Stage 2 Road Safety Audit – Designer’s Response

- 1.1 A Stage 2 Safety Audit of the proposed highway works and internal highway layout associated with the proposed development of 52 dwellings at Meadow Road, Neath has been undertaken by J Bartlett Consulting Ltd (September 2021).
- 1.2 This document serves as a designer’s response to any problems identified by the Auditors and confirms where further works may be required.
- 1.3 This document should be read in conjunction with the Stage 2 Audit Report ref: JonesB/1256.

Client: Jones Brothers & Tai Tarian
Project: Meadow Road, Neath
Title: Section 278 General Arrangement Plan
Ref: 2430/550
Rev: -

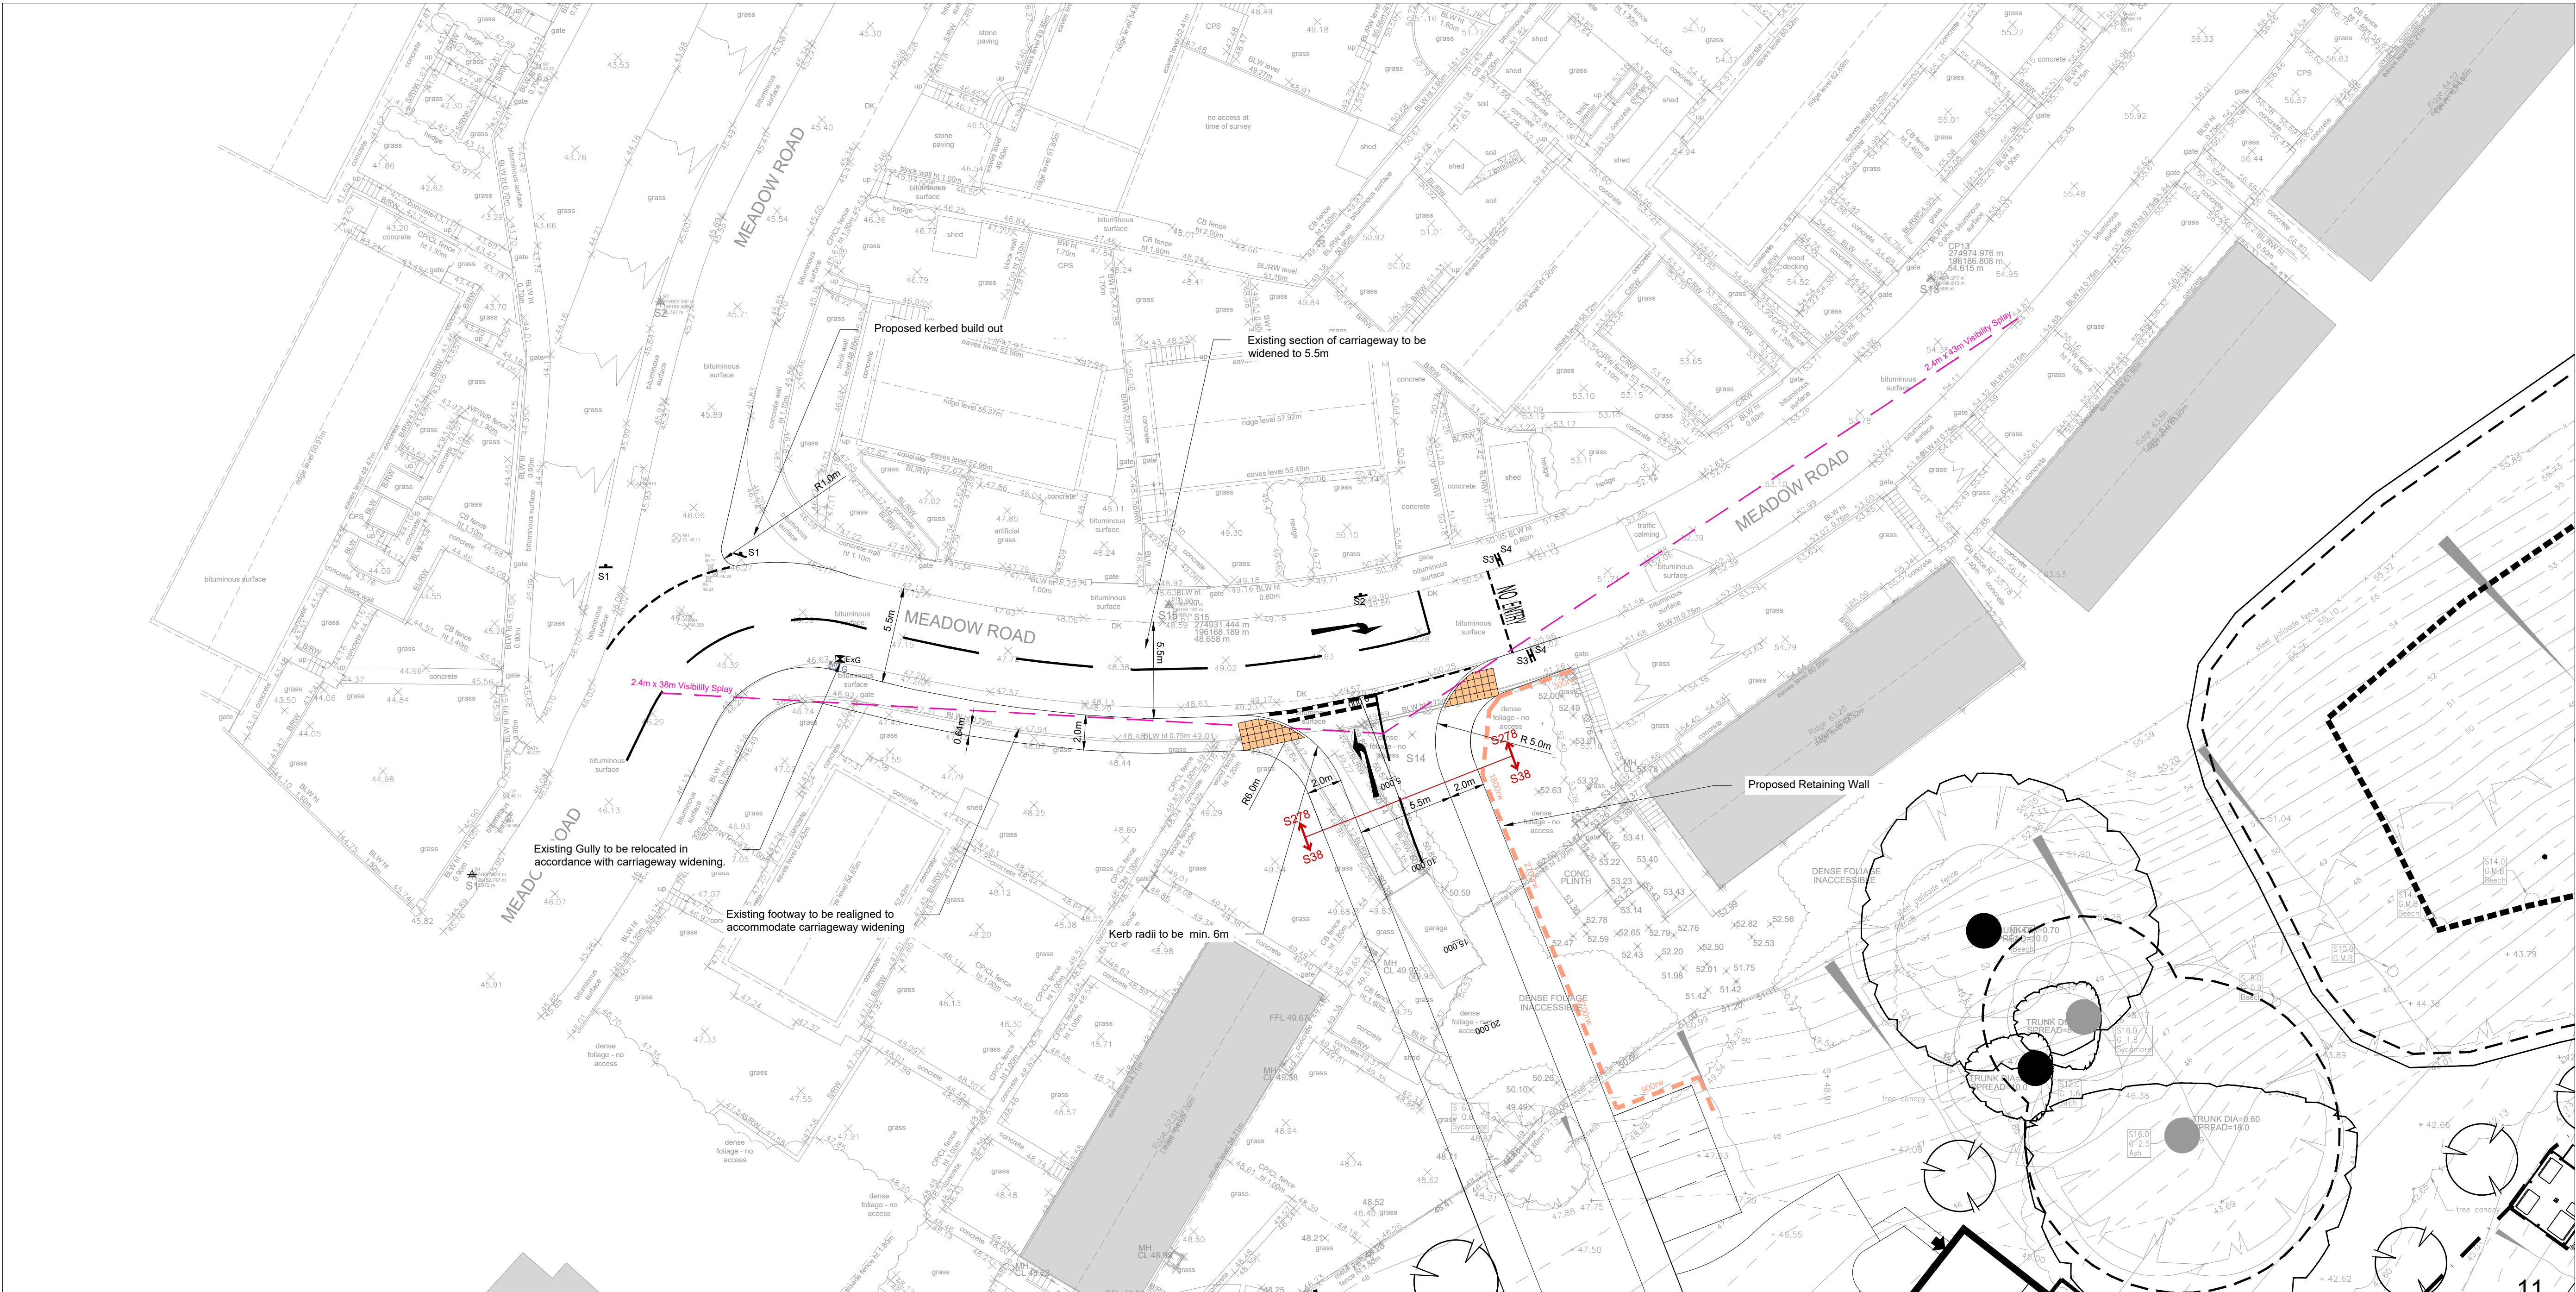
- 2.3 *No issues.*
- 2.4 *Site Access – No pedestrian crossing facilities indicated*

Please see enclosed drawing 2430-550 – S278 General Arrangement Plan which indicates a proposed inline uncontrolled pedestrian crossing.
